SUBJECT: NuScale Power, LLC Supplemental Response to NRC Request for Additional Information No. 332 (eRAI No. 9245) on the NuScale Design Certification Application

Response to Request for Additional Information Docket No. 52-048

eRAI No.: 9245

NRC Question No.: 12.03-8

Figure 2 Control Rod Drive Shaft Base

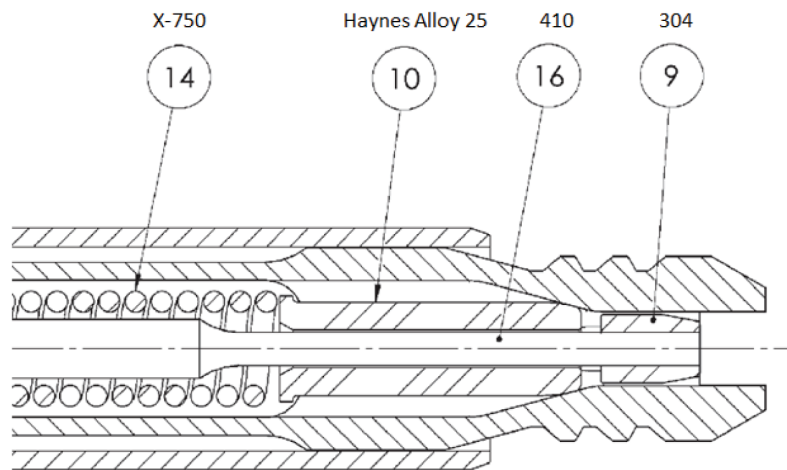
To facilitate staff understanding of the application information sufficient to make appropriate regulatory conclusions with respect to potential Co-60 contamination from the CRDM, the staff requests that the applicant:

1. Explain/justify the amount of allowable flexure for the control rod drive shaft, including the limiting number of cycles, the basis for the stated flexure value, and the expected material wear rates,
2. Explain/justify the testing that will be performed to assess the actual amount of control rod

drive shaft flexure,

3. As necessary, revise and update section 12.3 of the NuScale DCD to specify the design features of the control rod drive shaft provided to minimize the introduction of cobalt due to flexure,

The Cobalt item, at the base of the control rod drive shaft, is the coupling expansion plug, item 10, depicted in Figure 2. The design of this latching interface is similar in form and in material to the control rod latching mechanisms in service in the existing fleet. In these existing applications Haynes Alloy 25 has proved to be the appropriate material for these applications. Since this item is inside the control rod drive shaft, there will be very little motion due to any shaft bending (flexure) motion during a SCRAM. The vertical motion is also expected to be similar to that of similar mechanisms in the existing fleet. Industry experience has shown that Haynes Alloy 25 is the appropriate material for this application.
